Retract hole position "C-C" Sectional area

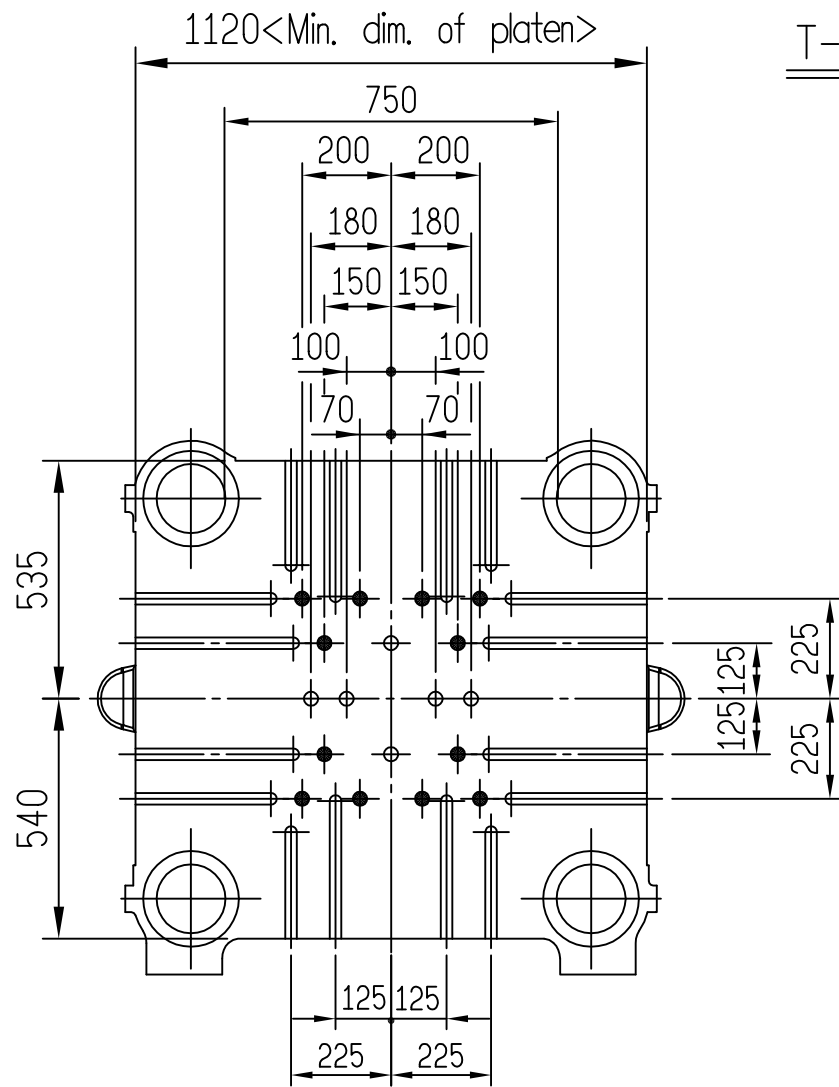
Re:<01> Dimension 225x200<4holes> retracting holes position are different with old generation  
old generation is 225x225<4holes>
